MILITARY SPECIFICATION

FUZE, ROCKET: M439
PARTS AND ASSEMBLY WITH DETONATOR

This Amendment forms a part of Military Specification MIL-F-48877 (AR), dated 17 September 1982, and is approved for use by the U.S. Army Armament, Munitions and Chemical Command, and is available for use by all Departments and Agencies of the Department of Defense.

TABLE V First article test

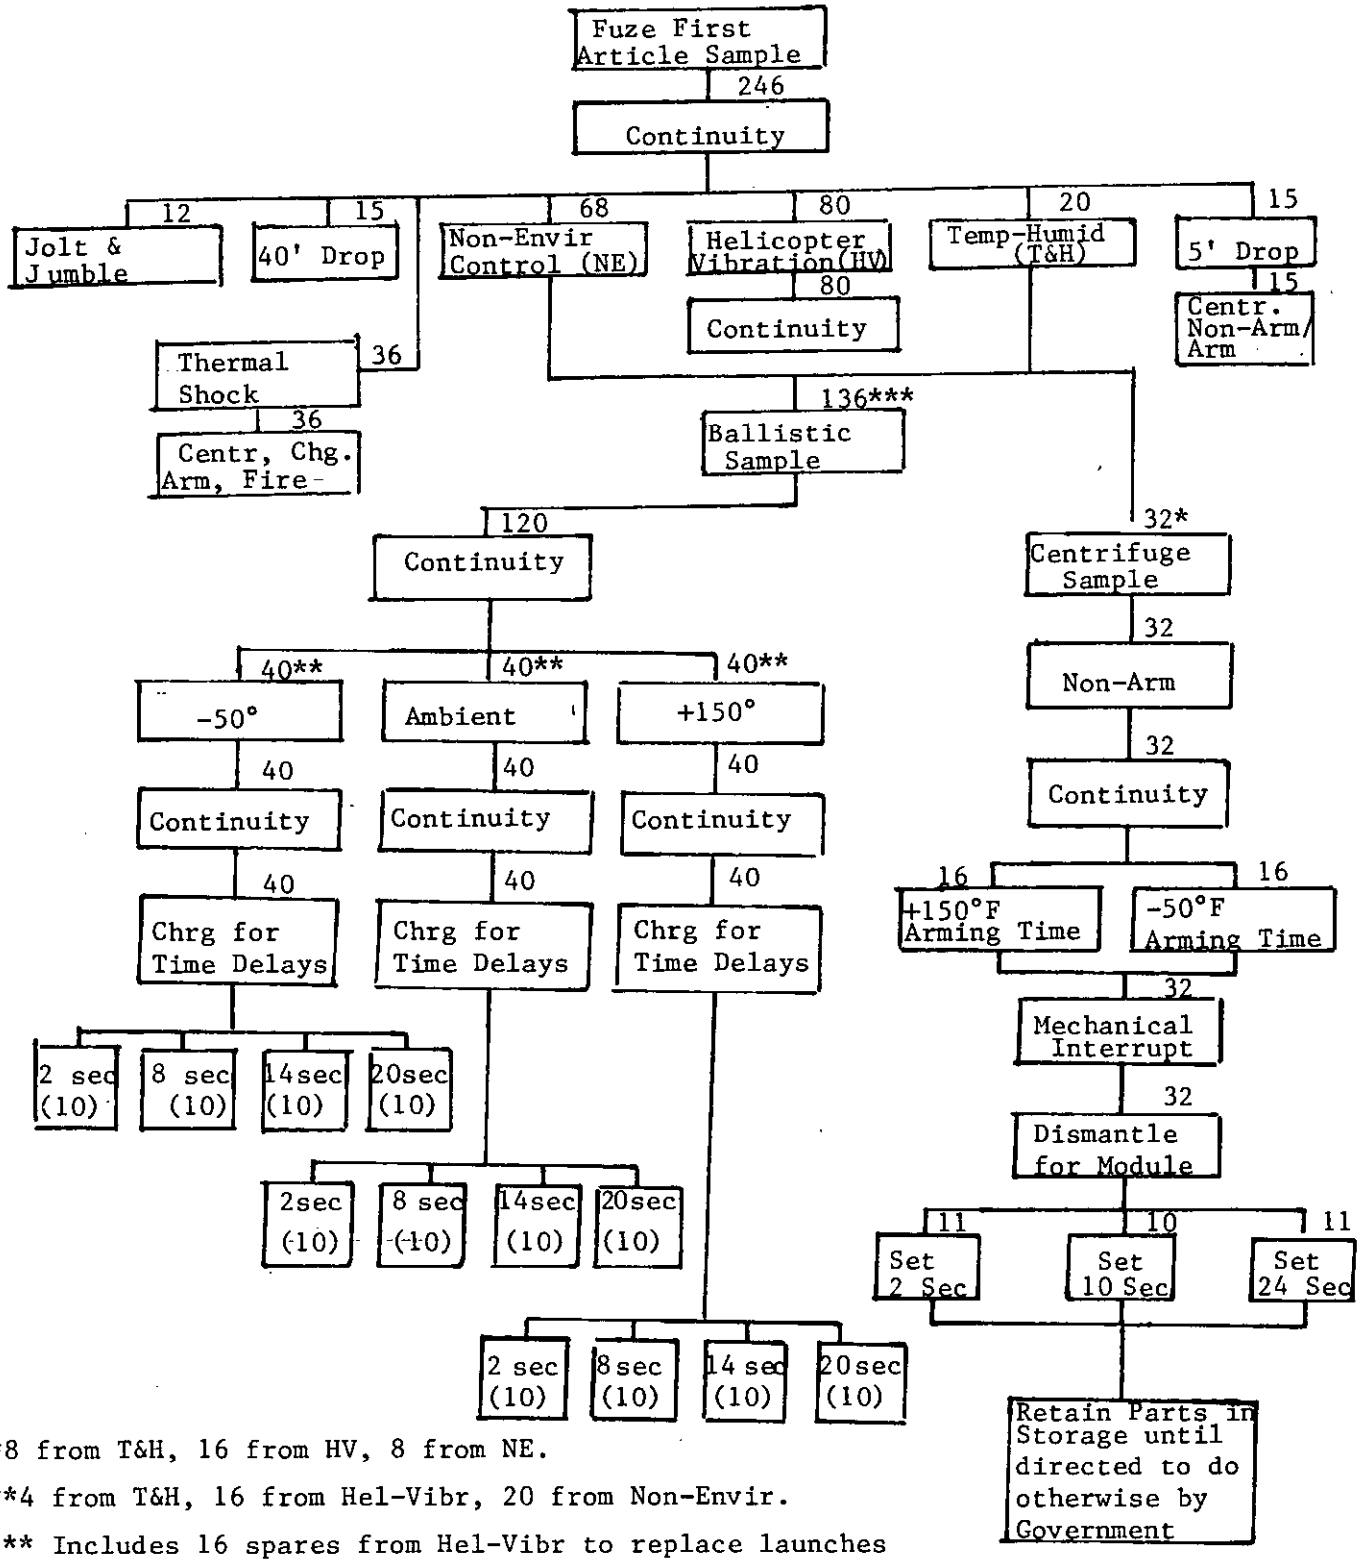
* TABLE V: Delete in its entirety and substitute new Page 81 (attached).

TABLE VII Fuze lot acceptance test

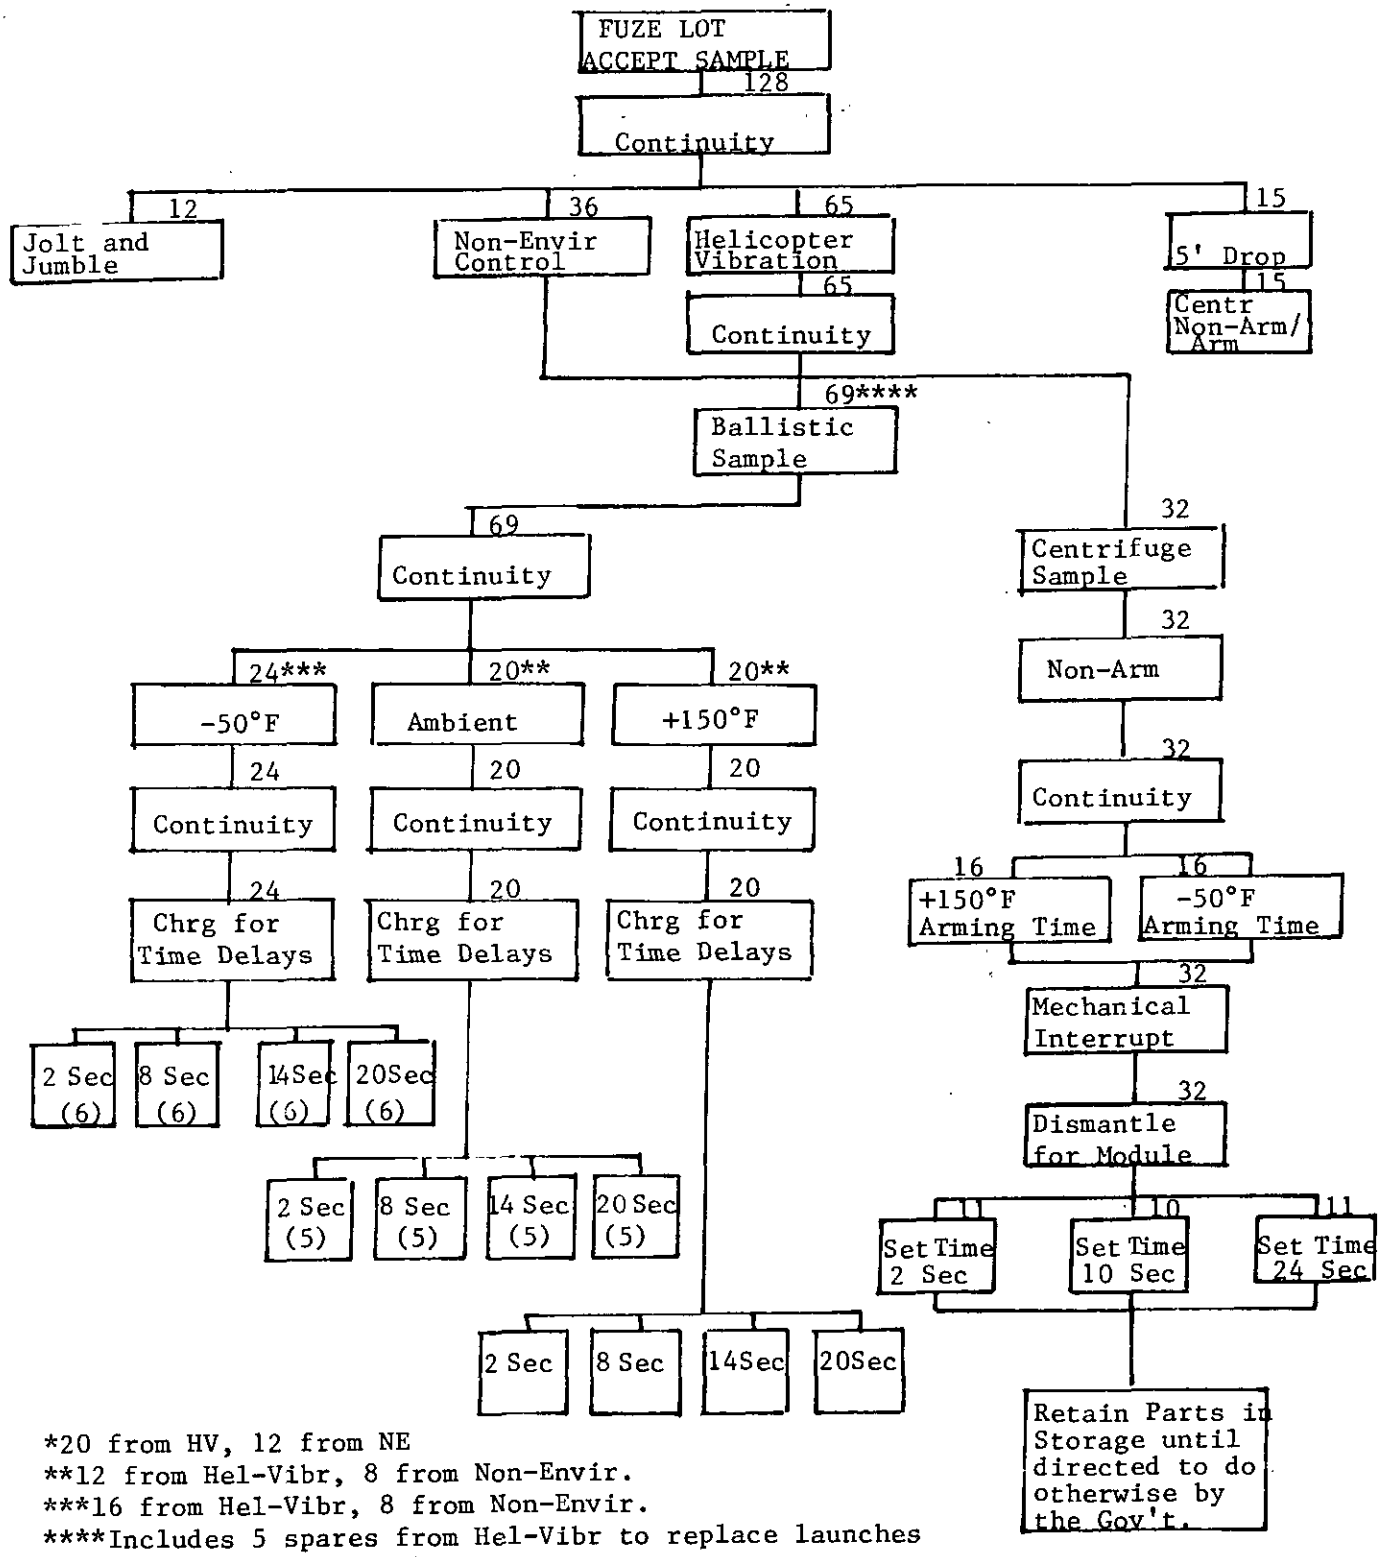
* TABLE VII: Delete in its entirety and substitute new Page 84 (attached).
